REMARKS

FIG. 1

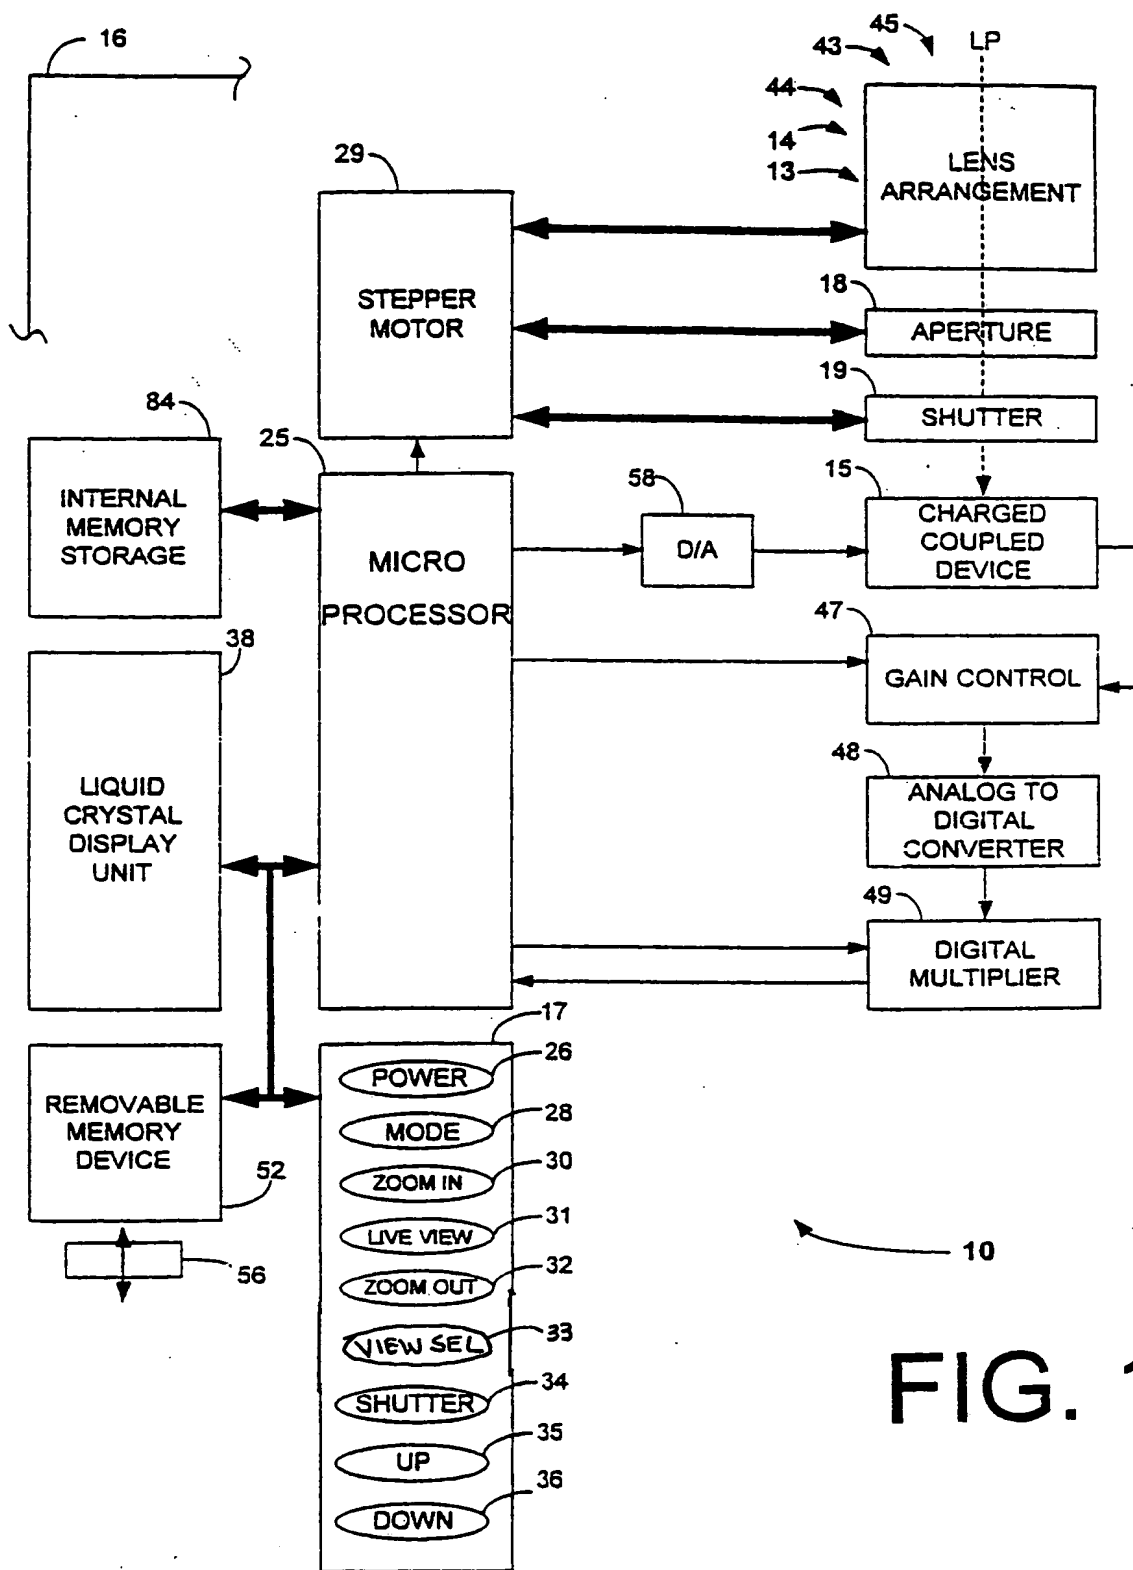
The drawings were objected to by the examiner because Fig. 1 did not include reference numeral 33. A copy of Fig. 1 is transmitted herewith with the proposed drawing correction indicated thereon in red ink. More particularly, Applicant proposes to add an oval with the term VIEW SEL and a reference numeral 33 to illustrate the view select switch 33 described on page 8, line 2 of the specification. No new matter has been added.
